# WATER QUALITY MEMORANDUM

## Utah Coal Regulatory Program

RE: Fourth Quarter 2016 Water Monitoring, Bowie, Fossil Rock Mine, C/015/0009, Task ID #5383

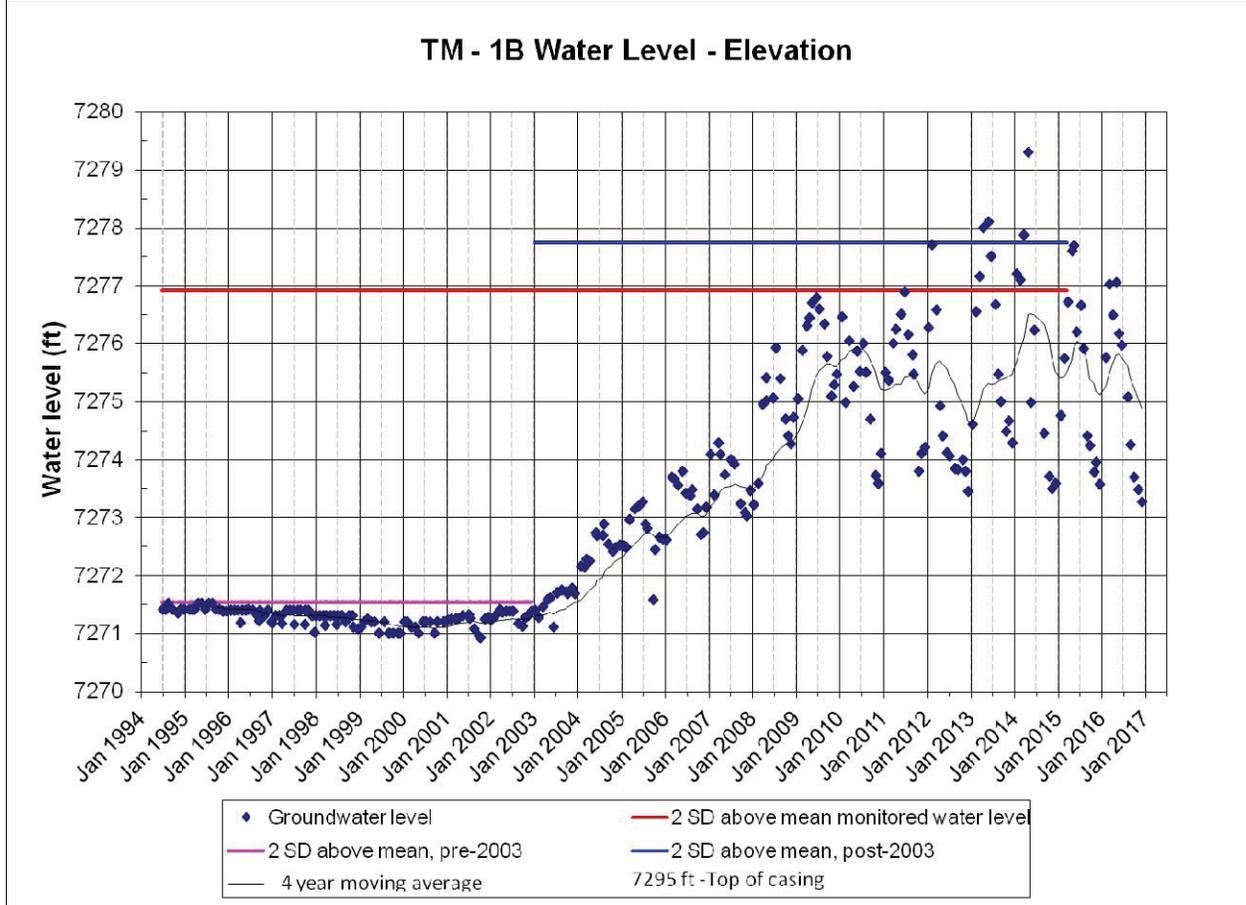
Well TM-1B is monitored for water level monthly and for operational parameters quarterly (Figure 1). Since July 2004, the water level in TM-3 has been reported as potentiometric head above the well casing by measuring the pressure on top of the sealed wellhead with a gauge (Figure 2). CCCW – 1A, CCCW – 1S, CCCW – 2A, CCCW – 3A, CCCW – 3U, CCCW – 3L are monitored for water level only (Figure

Figure 1. The water level in TM-1B has been rising since mine dewatering ceased in May 2001. It's difficult to say where this value will come to rest. The well is completed in the Panther tongue of the Star Point sandstone below the mine workings. This tongue contacts the floor of the mine workings. Mine dewatering reduced the potentiometric head within the unit and the mine pool is recharging the unit.

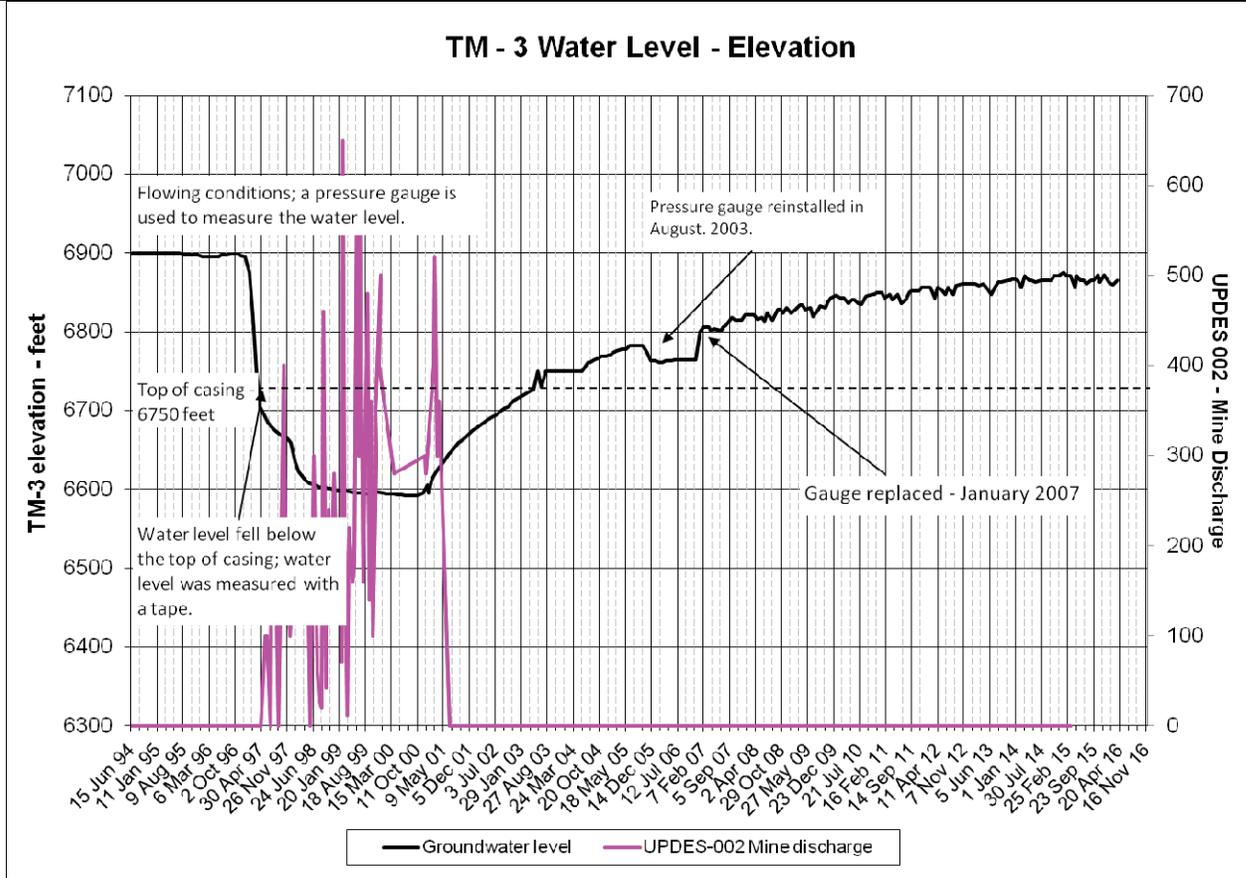
Figure 2. TM-3 water elevation peaked in June 2005, remained steady through October, dropped 18.5 ft in November and December 2005 and remained virtually unchanged during 2006. The pressure gauge was replaced in January 2007 and values jumped to approximately match the pre-2006 curve. During the first half of 2007 the curve was relatively flat, but it has been steadily climbing. The outgoing document Reduce Hydrologic Monitoring Sites, PacifiCorp, Deer Creek, C/015/0018, Task ID #4332 stipulates this well should not be released until 6,900 ft is reached.

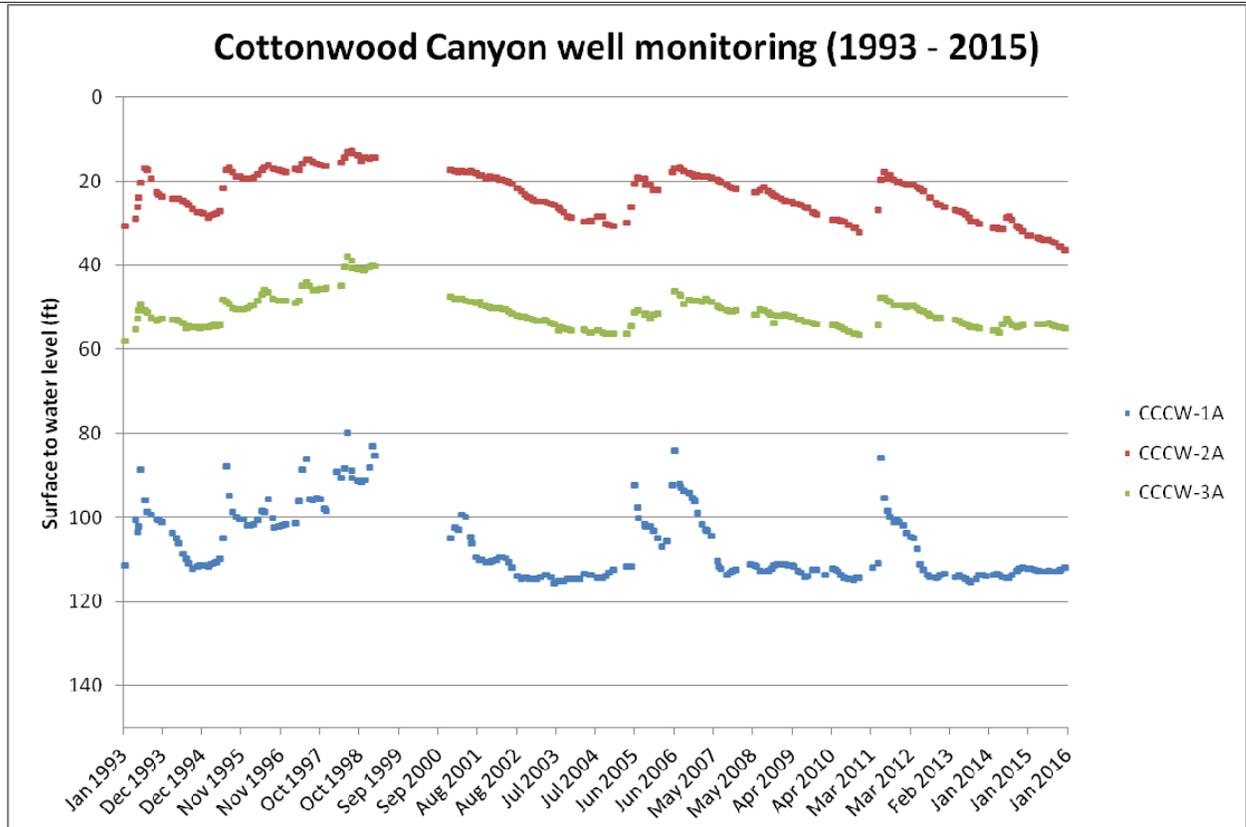
CCCW-2A continues to decline in elevation.

Figure 3. Alluvial aquifer water levels in the Cottonwood Canyon Creek monitoring wells. The drill hole data is found in Trail Mountain MRP Appendix C p. 23. This graph will be updated when mining begins in the Cottonwood Track. At this time the wells are primarily responding to climatic variability.
